Product Bulletin

February 2017

GOFREE® FLEX PRO – IDENTIFYING NEW VERSIONS

NEW VACUUM VERSION:

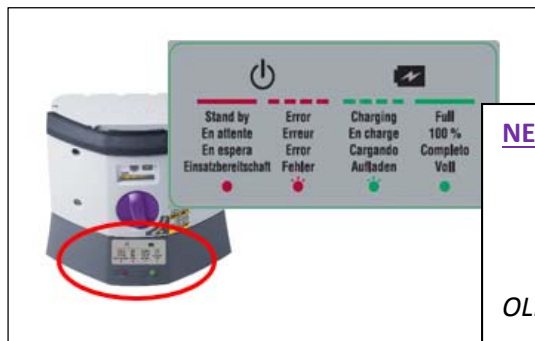
- New vacuum serial numbers will begin with “17” – to indicate manufacture in 2017
- New battery that comes with a new vacuum purchase will have a purple locking knob
- New icon on the vertical product label to indicate the new higher-productivity motor included
